## TECHNICAL BULLETIN: 14-12 (Revised)

**DATE:** April 23, 2014 - **Revised:** January 30, 2015

**SUBJECT:** New PCI PTS POI v3.1 T9 EPP Keypad and Supporting Software

06200-20150 Kit, T9 Upgrade for Traverse US (pictured)  
06200-20250 Kit, T9 Upgrade for Traverse Canada

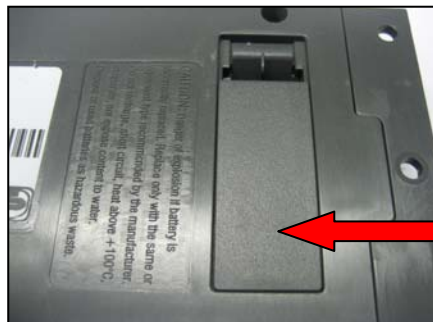
For Traverse, a hardware kit is necessary due to pressure switches. The following Kits are available to upgrade Traverse to T9.

**DESCRIPTION: (cont.) Revised.**  
**Battery replacement same as T5.**

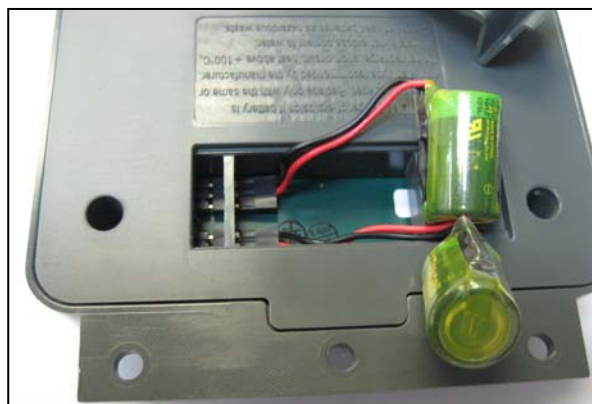
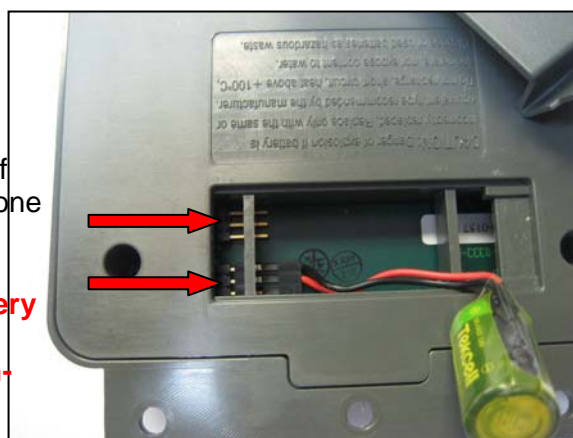
Locate the battery box cover on the back of the keypad and open.

Inside the battery box you will find two sets of battery contacts with a battery connected to one set.

**CAUTION: You must not remove the battery from the EPP until the second battery is connected. The EPP be permanently damaged if unpowered and the battery is removed.**

Plug the replacement battery into the second set of contacts.

Remove the original battery, tuck the new battery into the battery box, and replace the battery box cover.
